UNITED STATES
DEPARTMENT OF THE INTERIOR
BUREAU OF LAND MANAGEMENT

FORM APPROVED
OMB NO. 1004-0137
Expires: January 31, 2018**SUNDRY NOTICES AND REPORTS ON WELLS**
*Do not use this form for proposals to drill or to re-enter an abandoned well. Use form 3160-3 (APD) for such proposals.*5. Lease Serial No.
NMNM36975

☐ Oil Well ☒ Gas Well ☐ Other8. Well Name and No.
OXY STENT FEDERAL COM 12. Name of Operator
OCCIDENTAL PERMIAN LP

Occidental Permian LP - Current
 OPL Stent Federal #1
 API No. 30-015-34333

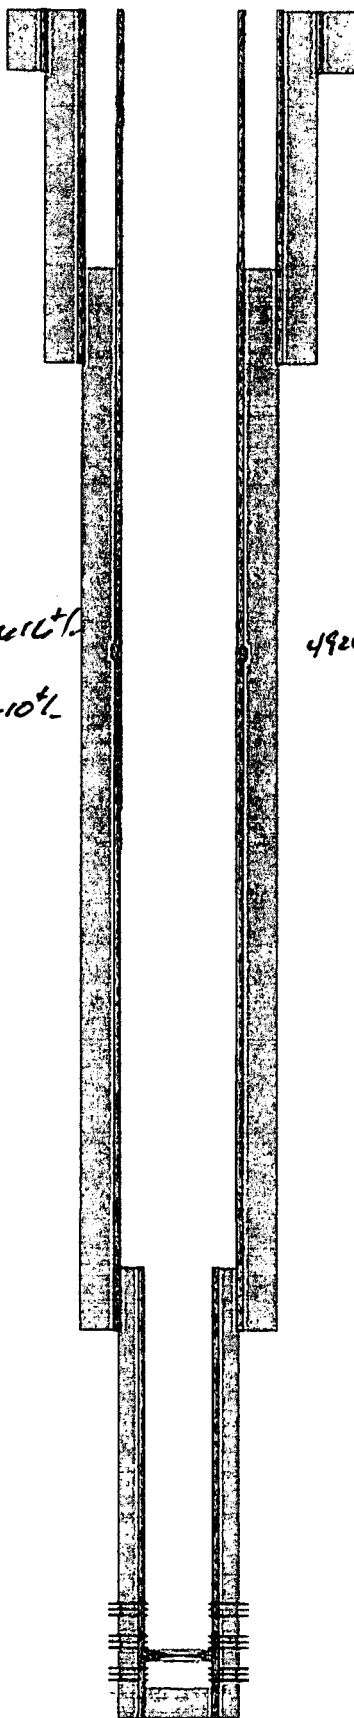
Add. for 1070. SQZ cmt 970 WOC Tag
(T/salt)

Resister 600' ✓
 Est Top T/Salt 1020' ✓
 8/salt 2605' ✓
 Del 2605' - 2610' ✓
 BS 6145' - 6610' ✓

Actual WC 940' ✓
 St 1151' ✓
 At 11710 ✓
 MR 12296 ✓

8-3/4" hole @ 10040' ✓
 7" csg @ 10040' ✓
 w/ 1450sx-TOC-2270'-TS Actual
 DVT @ 4920' 1100-75
 Est

Occidental Permian LP - Proposed
 OPL Stent Federal #1
 API No. 30-015-34333

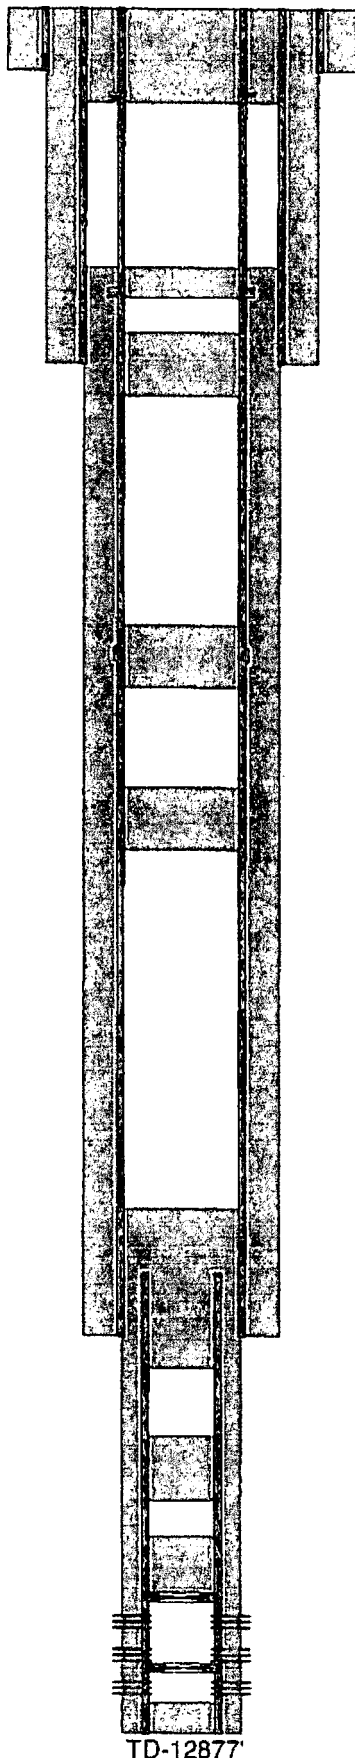
45sx @ 2365-2240' WOC-Tag *Blst*

60sx @ 2754-2465' WOC-Tag *Shoe / Des*

35sx @ 4995-4845' WOC-Tag *DVT*

50sx @ 6355-6110' WOC-Tag *ES*

90sx @ 10090-9355' WOC-Tag *WC*

30sx @ 11545-11239' WOC-Tag *ST*

CIBP @ 12260' w/ 30sx to 11950' *MR*
